# Addendum 2

DATE	01/23/2026
PROJECT NAME	BL572 – Intercollegiate Athletics Gymnasium – Replace Chiller, Heating Systems and Controls
INTROBA PROJECT #	2035.0013084
IU PROJECT #	20240613
DISTRIBUTION	Owner
ADDENDUM CONSIST OF	(1) 8.5 x 11 PAGES & (9) 30 x 42 PAGES

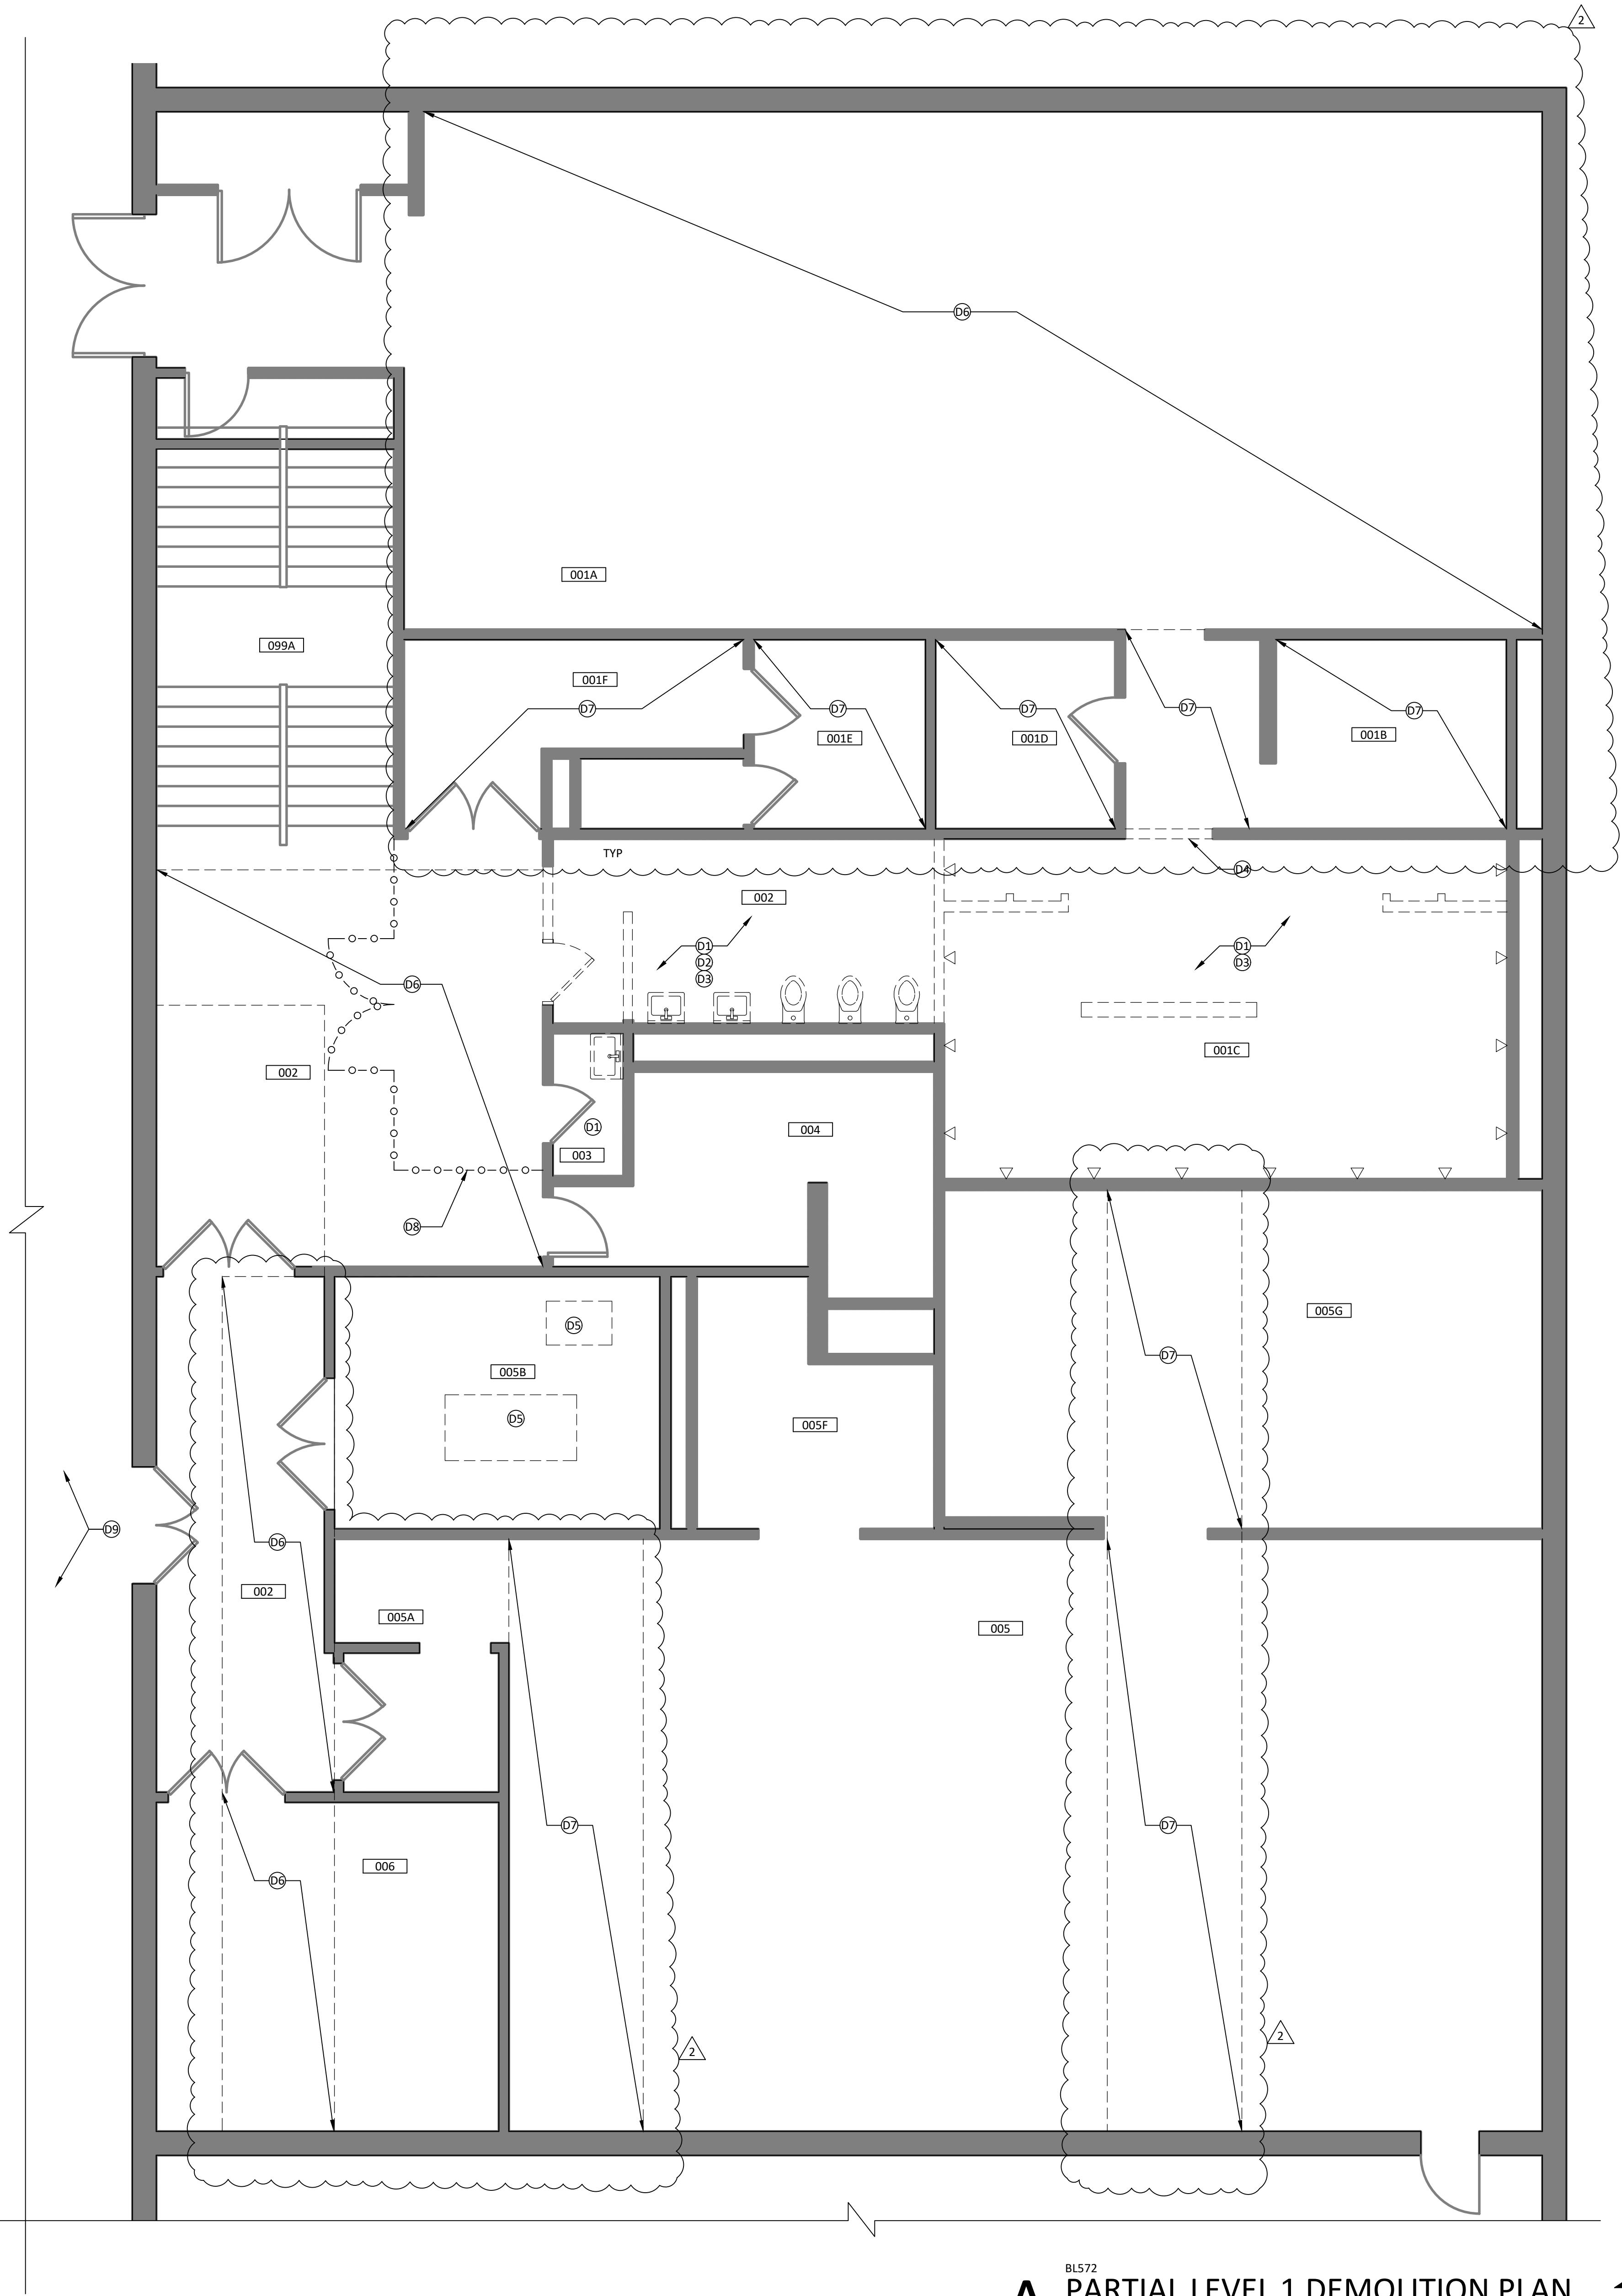
2. D-101 – ARCHITECTURAL DEMOLITION PLAN, LEVEL 01 ALTERNATE BID
  - a. Revised Demolition Note D7.
  - b. Revised Demolition Note locations as indicated.
3. A-101 – ARCHITECTURAL FLOOR PLAN, LEVEL 01 ALTERNATE BID
  - a. Revised Floor Plan Note 3.

- a) Contractor option will be to remove plaster ceiling complete and provide new suspended, (1) layer 5/8" gypsum board ceiling system, matching existing ceiling height, paint, at these rooms. Noted on D101, refer to Addendum 2.

- ⑦ REMOVE AND REPLACE EXISTING PLASTER CEILING SYSTEM AS REQUIRED FOR MEP WORK ABOVE, REFERENCE MEP SERIES DRAWINGS.
- ⑧ CONTRACTOR OPTION TO REMOVE PLASTER CEILING COMPLETE AND PROVIDE NEW SUSPENDED (1) LAYER, 5/8" GYPSUM BOARD CEILING SYSTEM, MATCHING THE EXISTING CEILING HEIGHT AT THIS ROOM, PAINT, AT THIS ROOM.

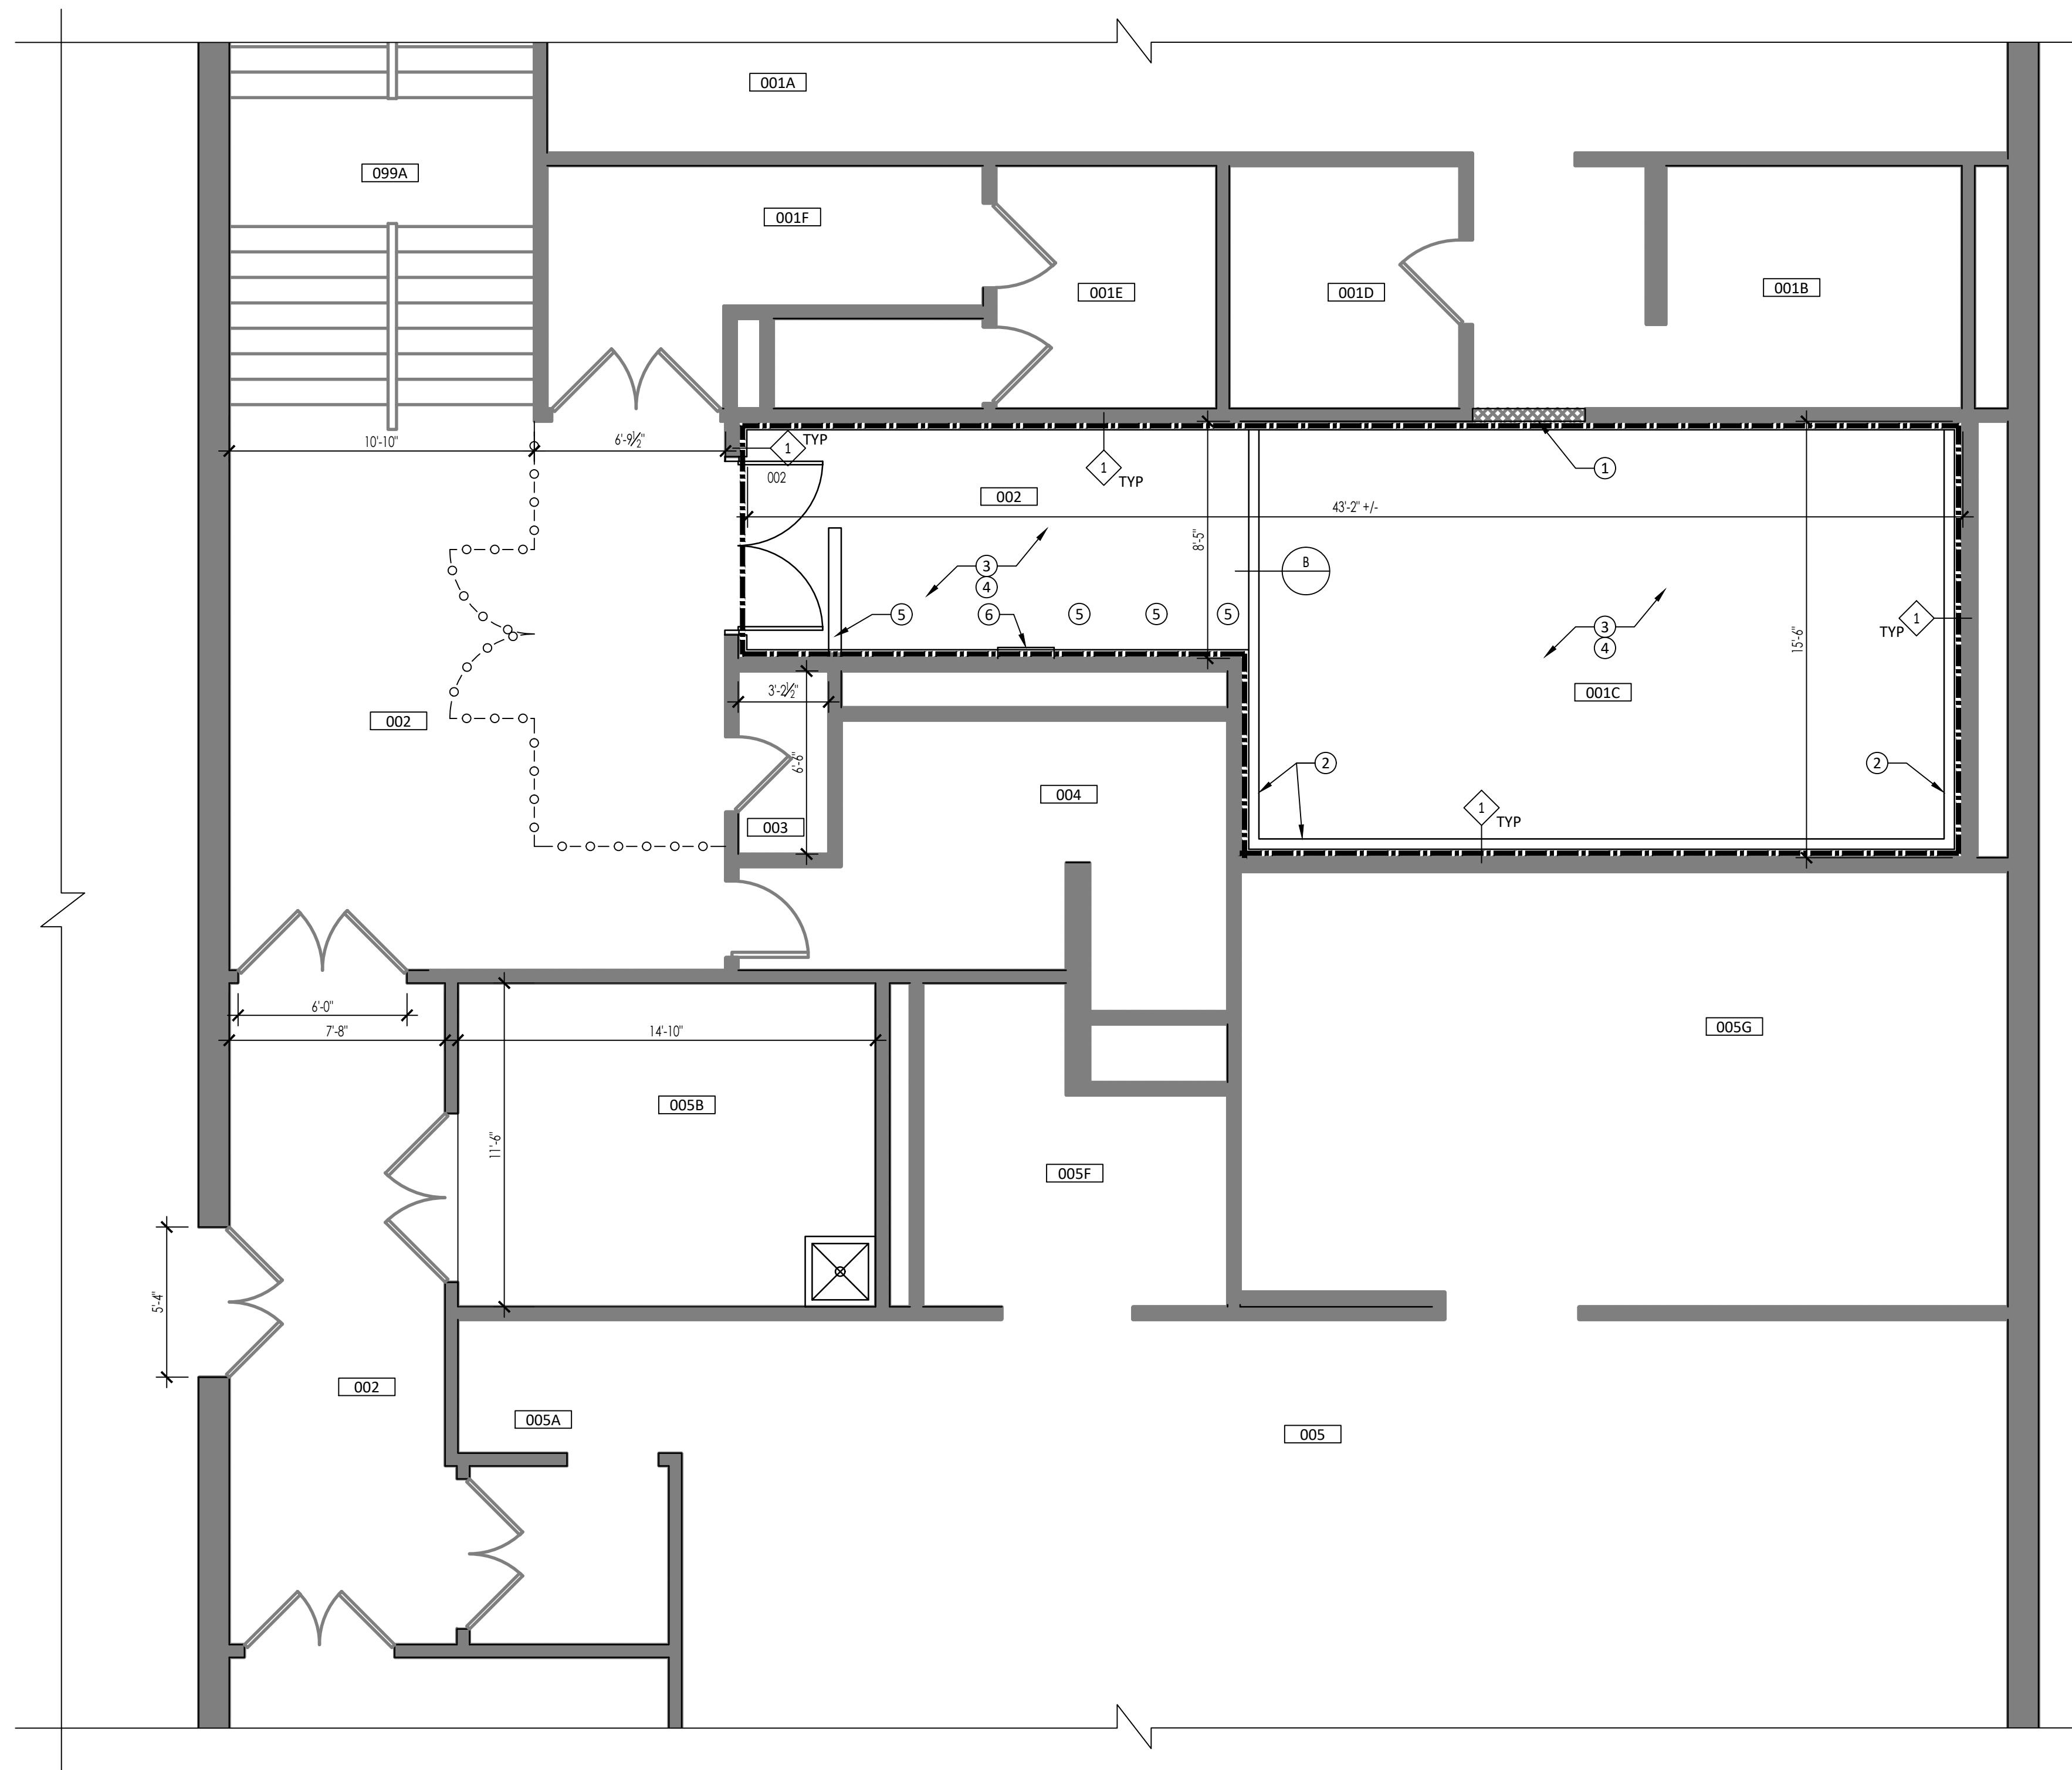
1. In the existing shower room, the ceiling calls to add channel directly to the bar joists and 2 layers of dry wall fastened to it. The drawings call for existing mechanicals and duct to remain. However, the hydronics and duct run just below the joists (photos attached). How would you like us to handle this on the bid?

- a) Revised note 3 on Sheet A101: "1-HOUR FLOOR CEILING ASSEMBLY, THIS ROOM. PROVIDE A SUSPENDED GYPSUM BOARD CEILING SYSTEM W/(2) LAYERS OF 5/8" TYPE 'X'. CEILING HEIGHT TO BE AS HIGH AS PRACTICALLY POSSIBLE. ADD 6" BATT INSULATION ABOVE NEW CEILING." Refer to Addendum 2.

- ① INFILL EXISTING CMU WALL, TOOTH-IN
- ② INFILL EXISTING SHOWER TRENCH, REF. DETAIL THIS SHEET
- ③ 1-HOUR FLOOR-CEILING ASSEMBLY, THIS ROOM PROVIDE A SUSPENDED GYPSUM BOARD CEILING SYSTEM W/ (2) LAYERS OF TYPE 'X'. CEILING HEIGHT TO BE AS HIGH AS PRACTICALLY POSSIBLE. ADD 6" BATT INSULATION ABOVE NEW CEILING.
- ④ CEMENTIOUS TOPPING SLAB TO CREATE LEVEL SURFACE, THIS ROOM. PREP EXISTING SLAB AS REQUIRED FOR PROPER BONDING.
- ⑤ PATCH EXISTING CERAMIC TILE FLOOR WITH CEMENTIOUS TOPPING.
- ⑥ PROVIDE 24x24, 1-HOUR RATED ACCESS DOOR IN NEW FRAMED WALL. REMOVE EXISTING CMU AS REQUIRED FOR FULL VIEW INTO EXISTING CHASE.
- ⑦ REFERENCE MEP SERIES DRAWINGS FOR NEW EQUIPMENT/HOUSEKEEPING PADS.
